# 3rd & Cherry

DESIGN REVIEW BOARD  
2<sup>nd</sup> RECOMMENDATION MEETING

Project Address: **601 4th Avenue**  
SDCI Project #: **3028747**

Design Response - Site Plan

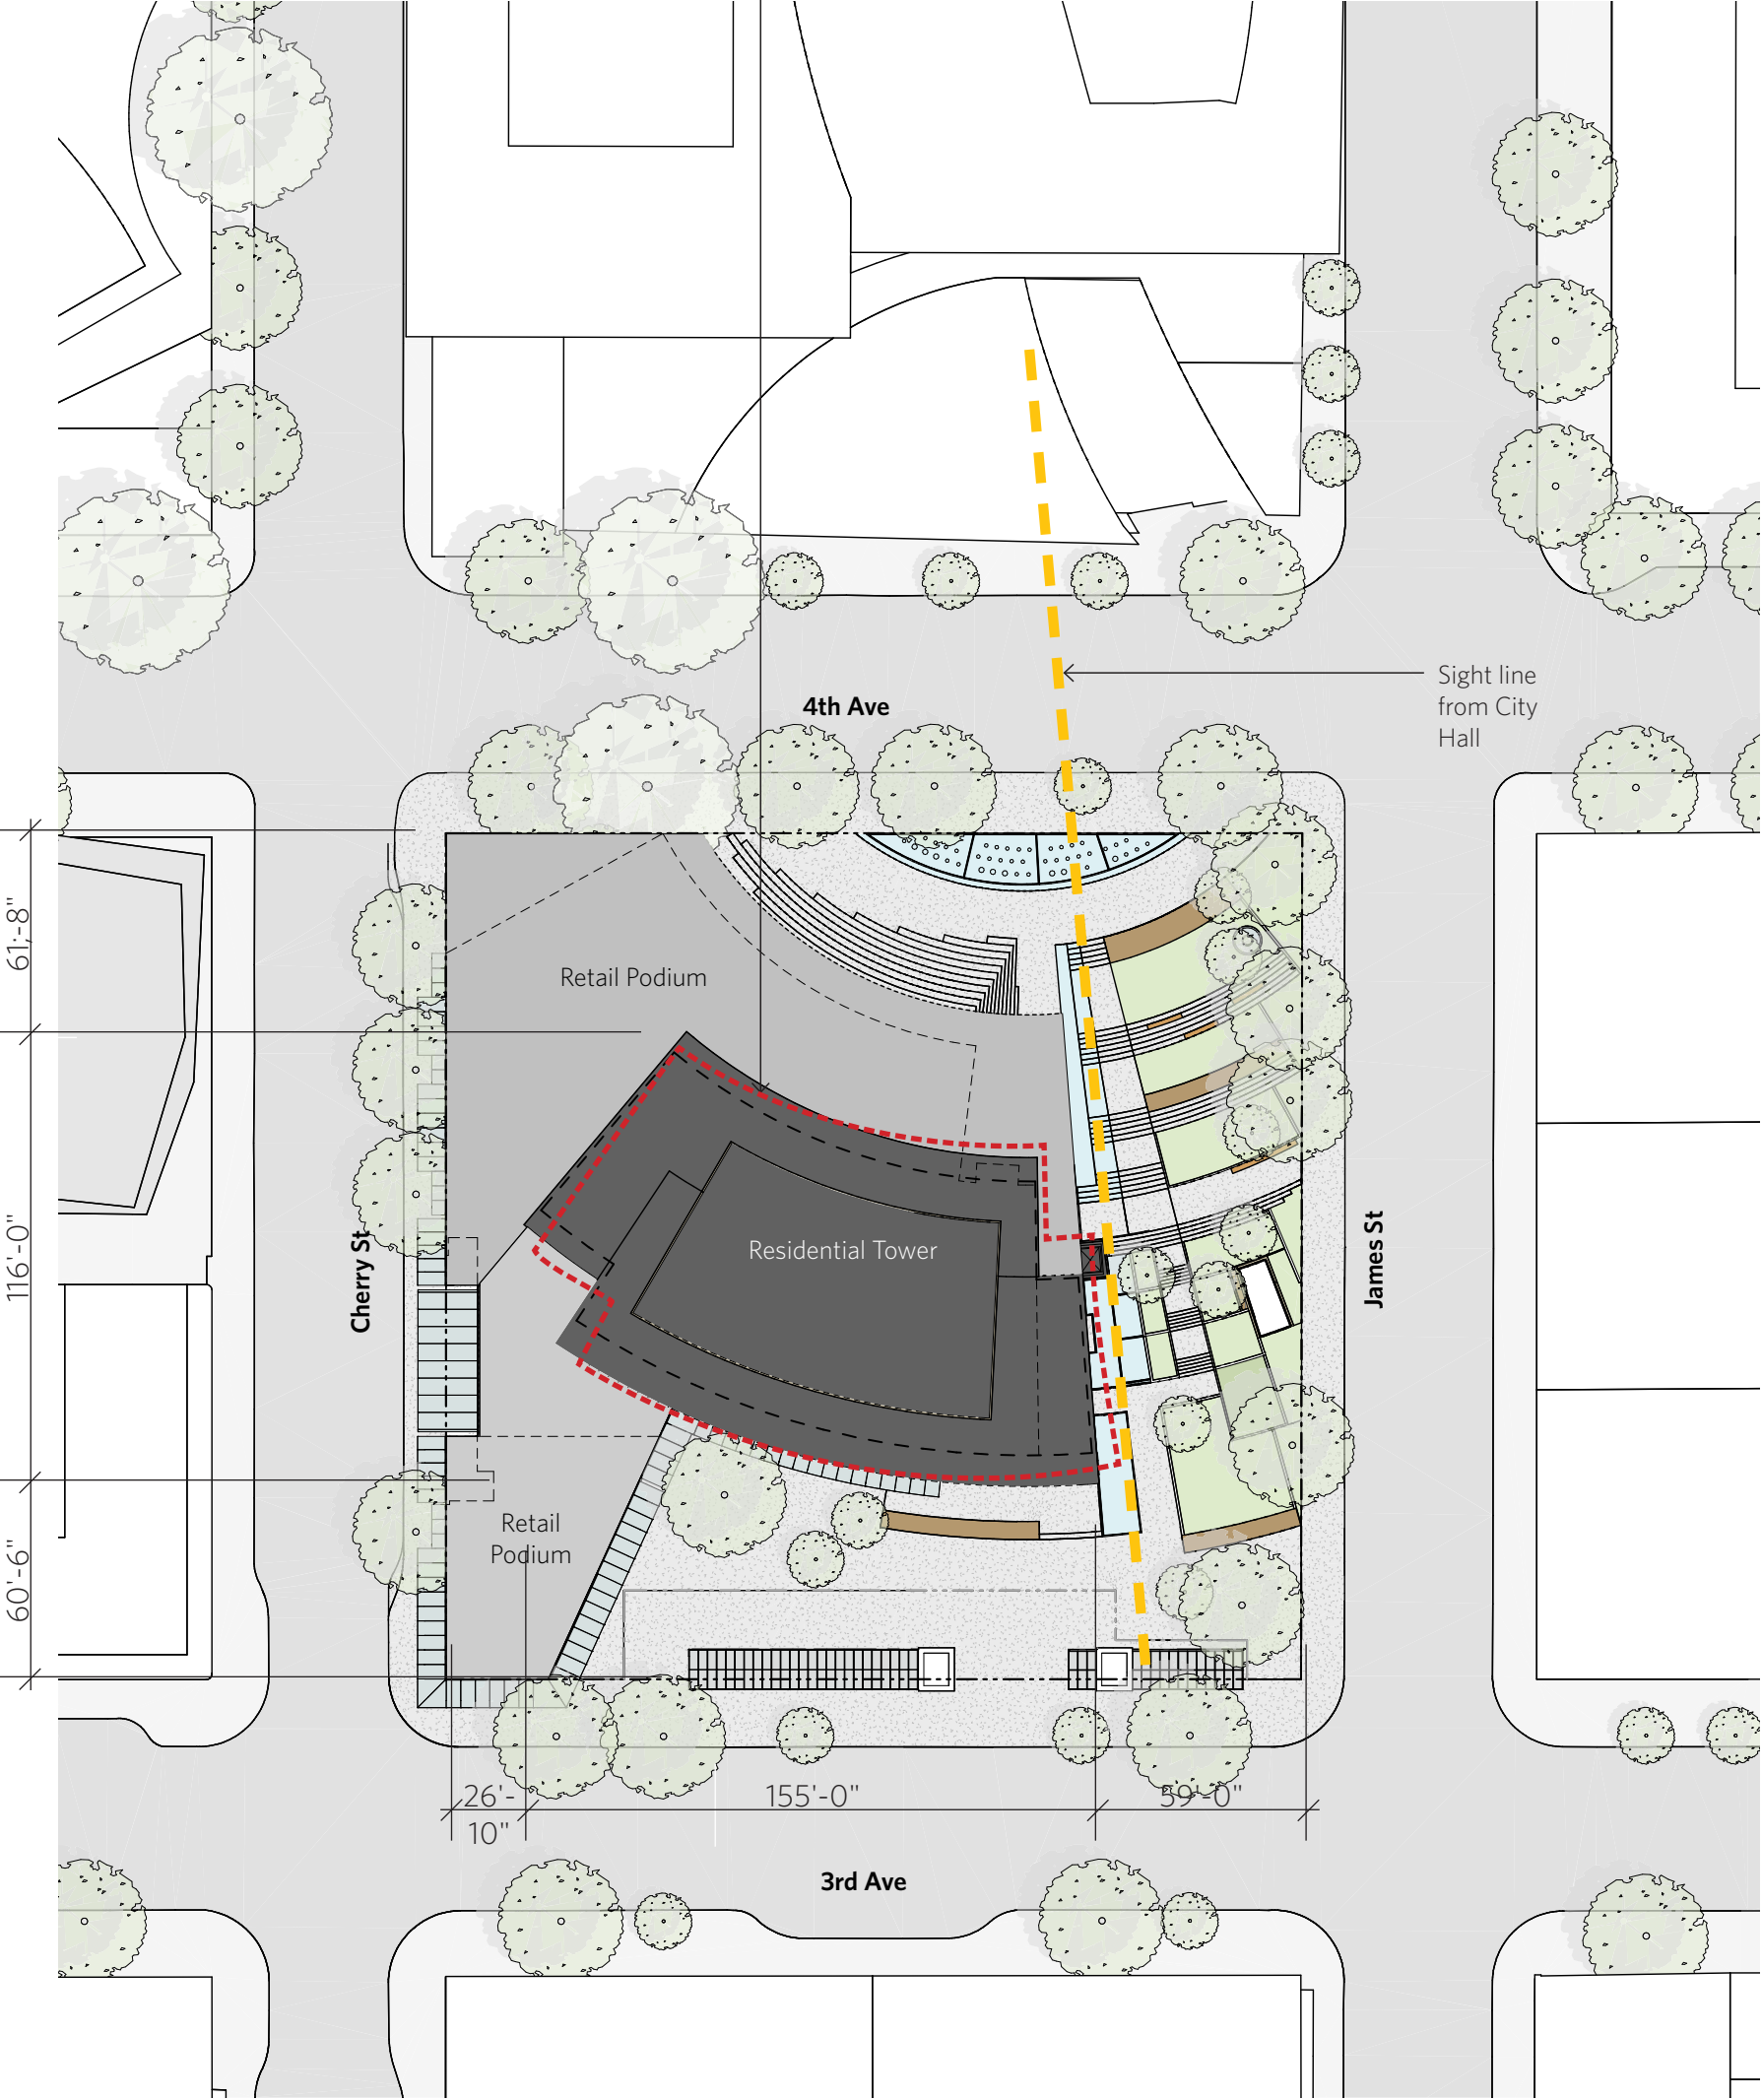
At the Initial Recommendation meeting a departure was requested to allow a tower with a width along 4th and 3rd Ave greater than the 120' width allowed by code. A departure for tower width had not been identified at either of the two EDG meetings. The Board observed that the amount of the departure request was large and struggled to find suitable justification to support the departure given in the Recommendation packet. The Board noted that at both EDG meetings the Board has either supported or given guidance for a tower location on the northern portion of the site, expressing at the 2nd EDG that they would be open to shifting the tower form further northeast, closer to the corner of 4th and Cherry St. (A1.1, B1.1)

The tower width has been reduced 5'-0" from DRB1 (from 160' to 155'). (Refer to Section 8.0 Departures for the proposed Tower Width Departure)

By reducing the tower width, the open space between the tower face and the City Hall/ Smith Tower sightline has increased by 6'-9".

Site Plan\*  
\*Dimensions calculated to the tower's exterior face

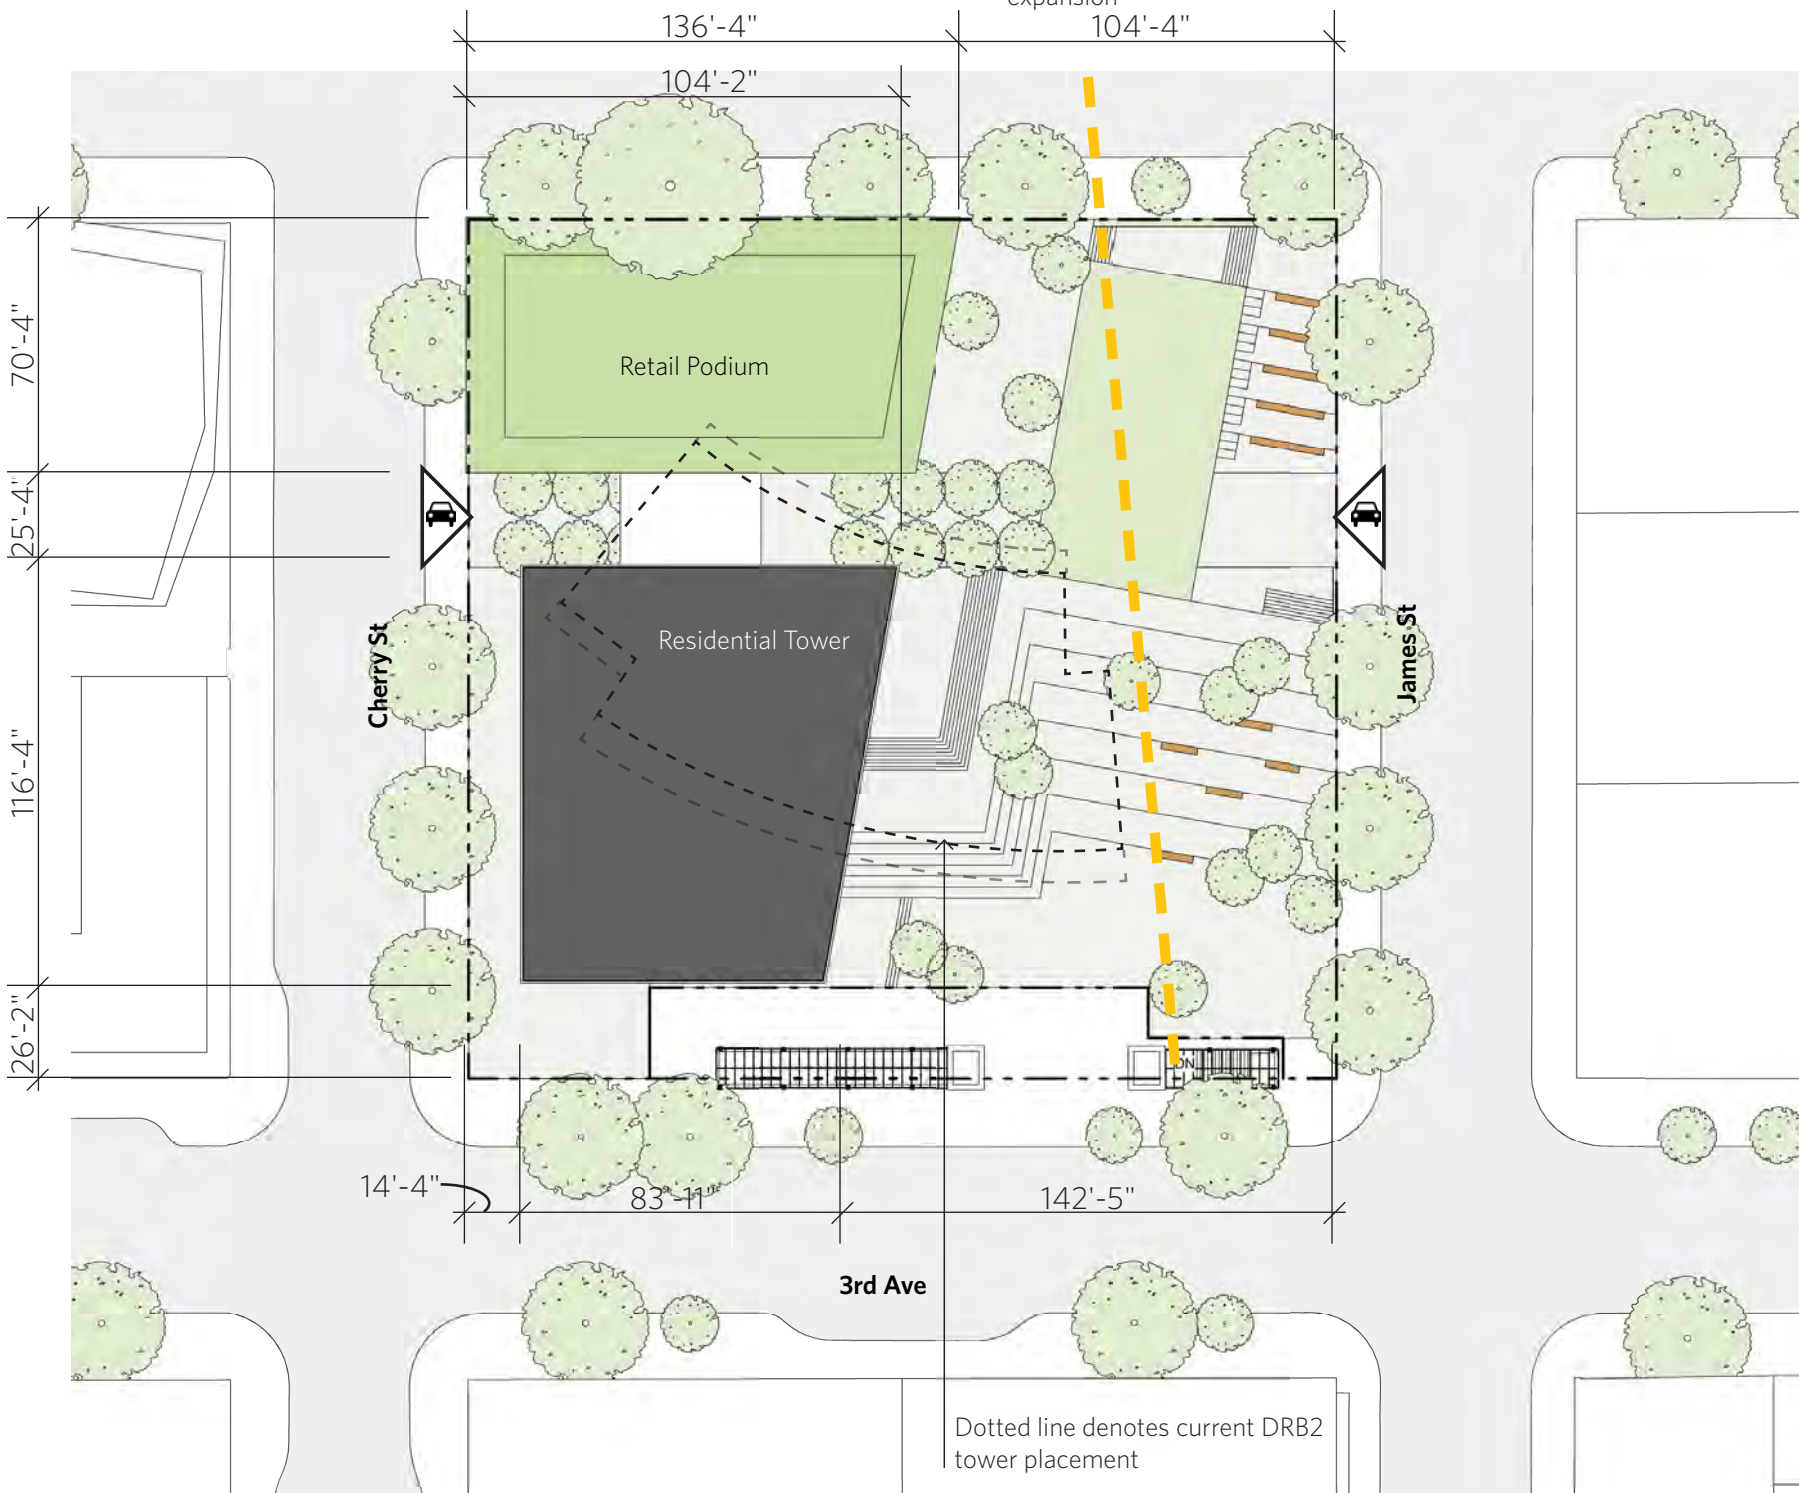
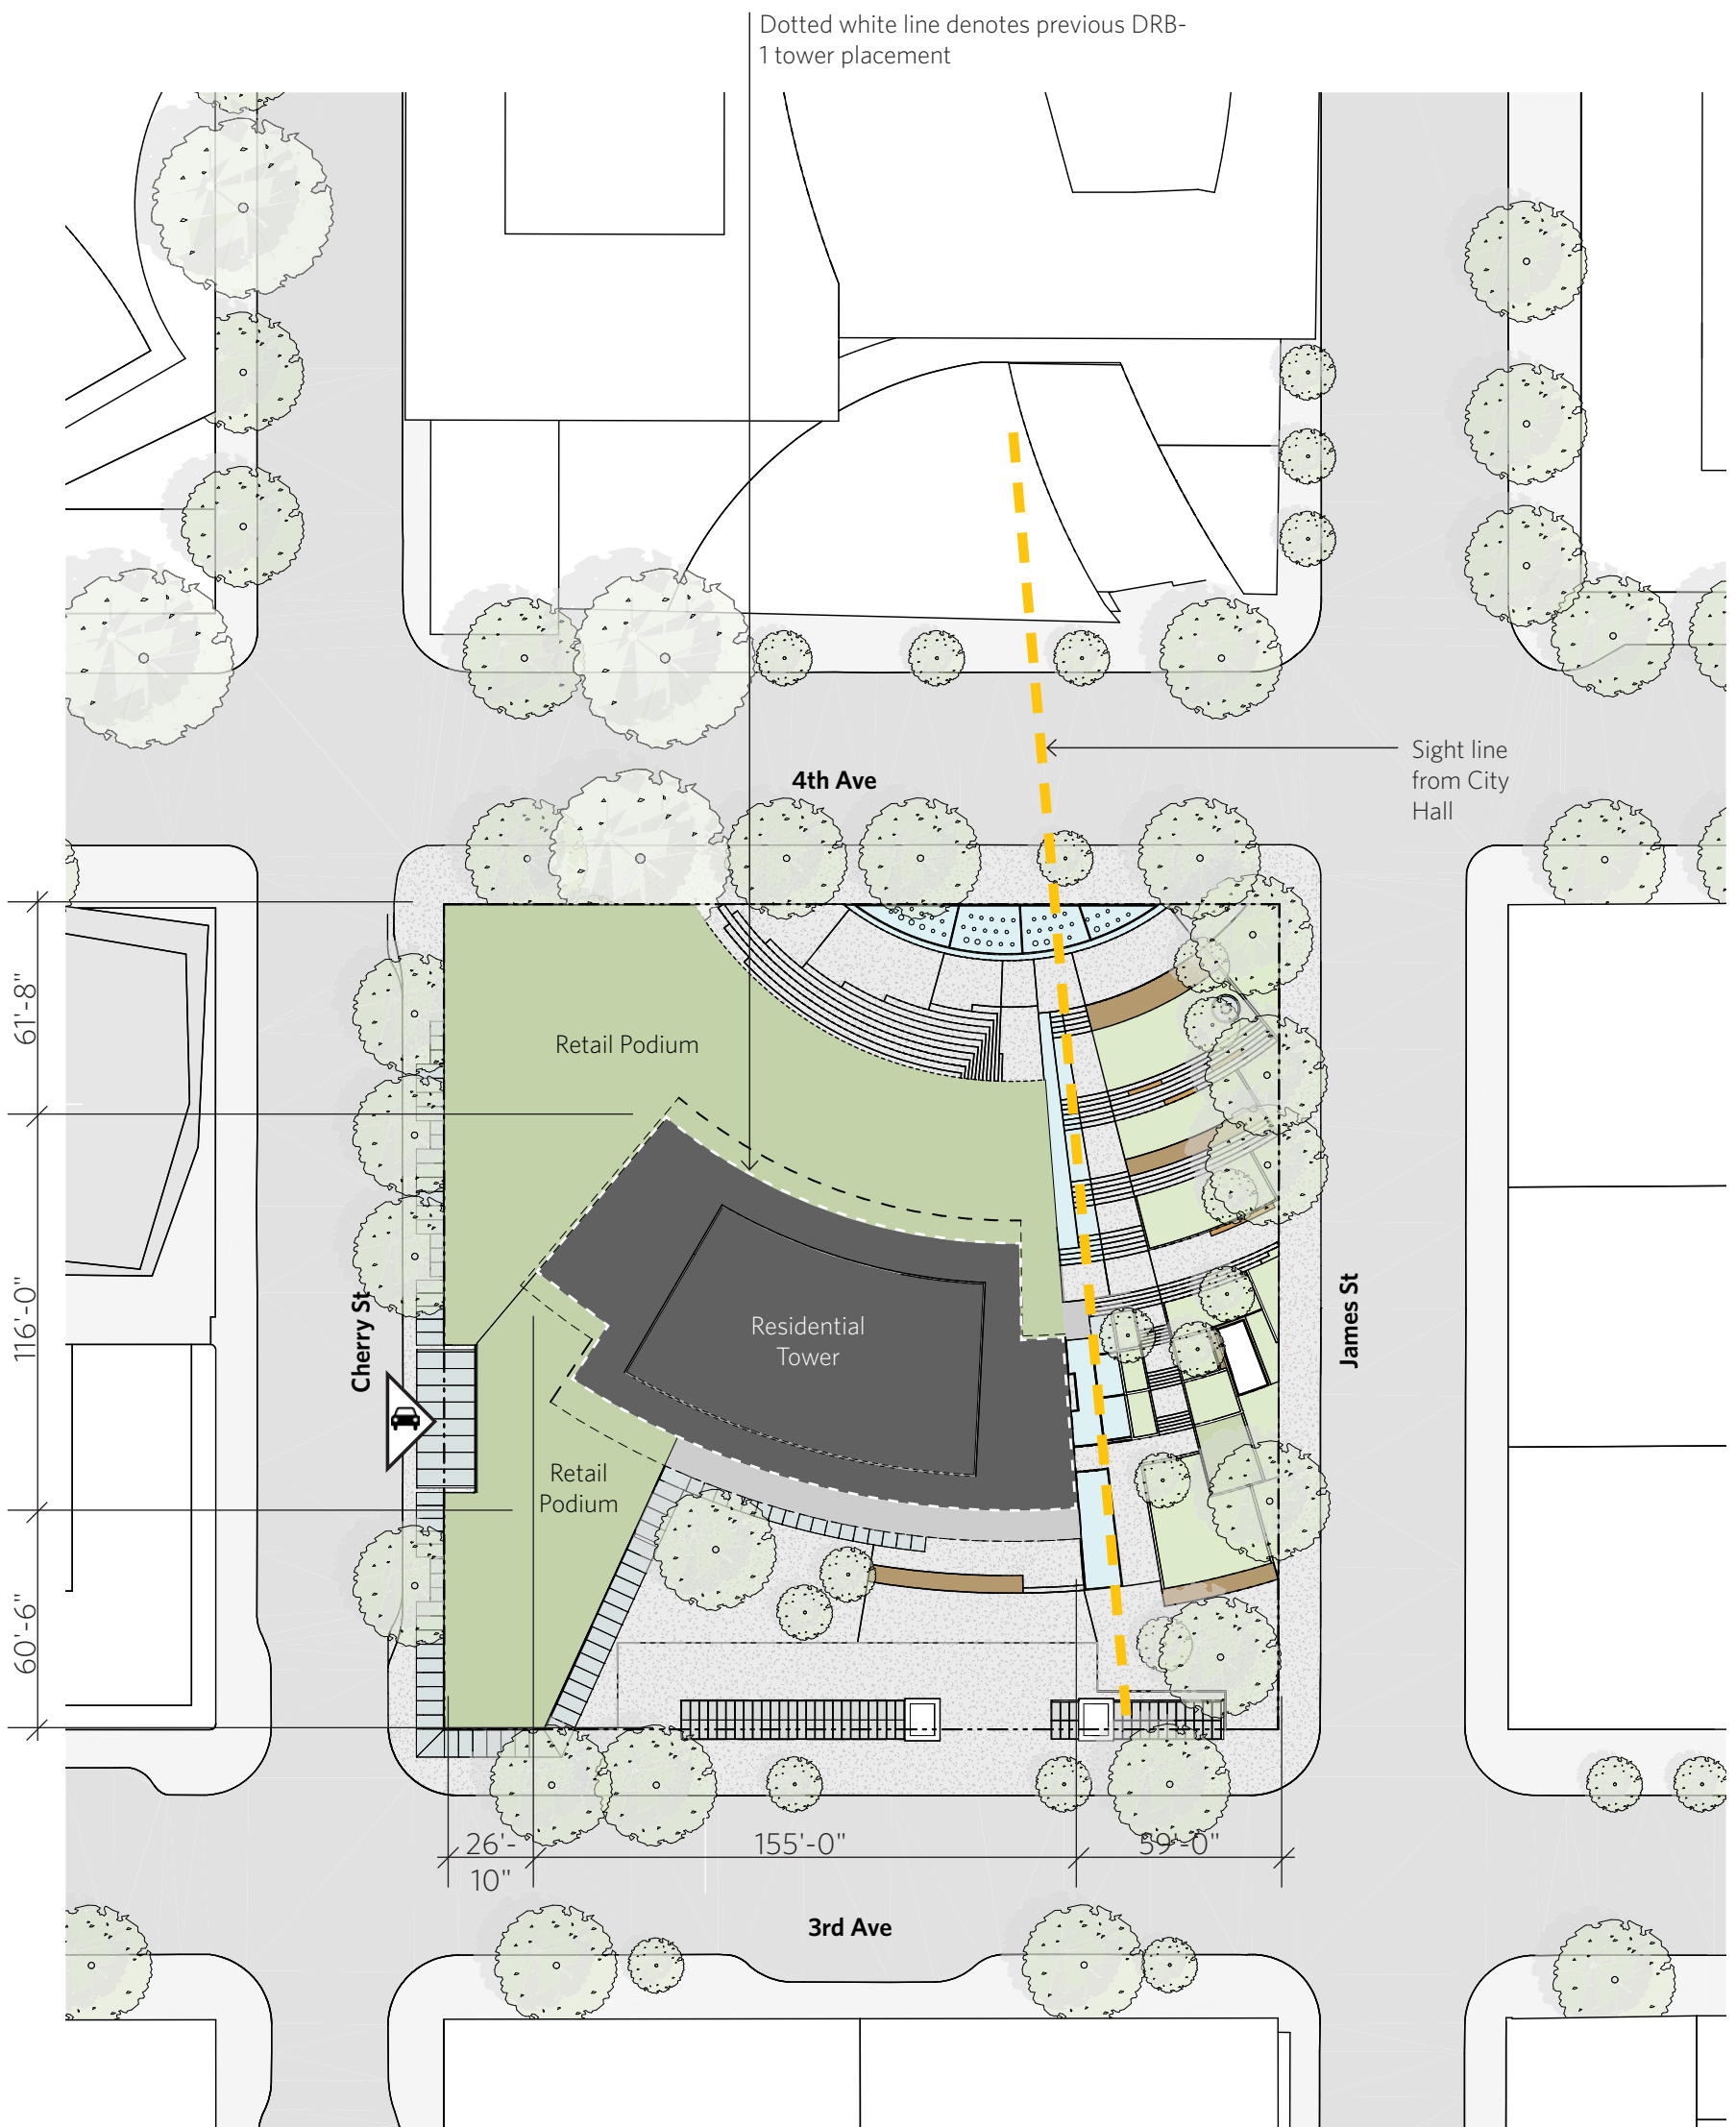
The Board requested the design team to provide at the 2nd Recommendation meeting a site plan and a massing study of a code compliant option to compare with the proposed tower mass and location. The “yellow” line shown on page 53 of the Initial Recommendation packet, should not move south. (A1.1, B1.1) See departures below.

The EDG1 Option 1 is a code compliant scheme. The disadvantages of this scheme are:

- Street Edges
  - Cherry Street: the pedestrian scale is substantially compromised
  - 4th Avenue: the retail massing doesn't match with the city hall geometry
  - James Street: does not address the street edge nicely
  - 3rd Avenue: the tower is pinched to the exiting transit entry, not engaging 3rd Avenue.
- Urban Context
  - This scheme does not respond to heritage buildings and block exposure of the Arctic Building
  - The tower is too close to the proposed tower across Cherry Street
  - Public view from City Hall terrace to the water along the Cherry Street is blocked
- Open Space
  - The urban plaza doesn't respect the geometry of city hall
  - This scheme doesn't have distinct open spaces (upper/ terraced/ lower plaza)
  - Tower pinches Sound Transits easement which doesn't allow for future expansion
